Cultural Heritage Subcommittee (CHSC)

SUBJECT: **Minor Cultural Heritage Permit (MCHP) 16-326, Myhren Shed**, a request to place a pre-fabricated shed in the back yard of a historic resource located at 245 Avenida Del Poniente, in the Residential Medium (RM-CZ) coastal zoning district, Assessor's Parcel Number 692-081-02.

MCHP 16-326, Myhren Shed

RANCH MODEL: 10x12 Pro Tall Ranch INSTALL DATE: _____

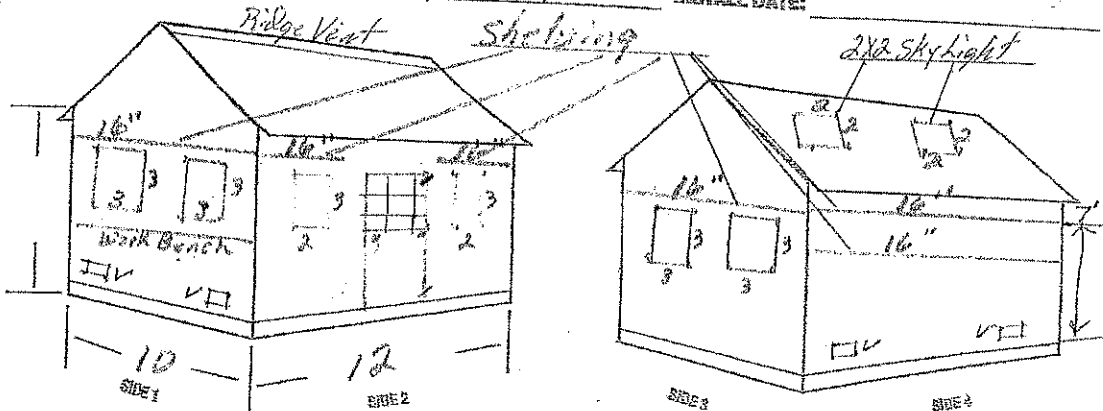
The proposed shed would not be visible from the street as it is located at the rear of the property away from public view. The shed is proposed at 10 feet wide and 12 feet long, and stands approximately 10.5 feet in height. The structure is proposed as a white "frost" color, consistent with the color of the home, and the trim and door of the structure is a dark brown "ground coffee" color, also consistent with the trim of the home. Although the shed is not Spanish Colonial Revival, the shed design and colors are consistent with sheds constructed during that architectural style era. Staff is of the opinion that the wood shed design is consistent with that time. It would have been common for a property owner of that era to construct a wood shed in the rear portion of their property.

The proposed shed will not impact the look or integrity of the historic structure, will be consistent in color and design from that era and is not visible from the street. Therefore, the request is supported by staff with one recommendation for improvement.

Staff recommends the applicant utilize Spanish Colonial Revival hardware (door handles, brackets, etc.) during construction if feasible. Staff seeks CHSC's concurrence and welcomes any additional comments or recommendations.
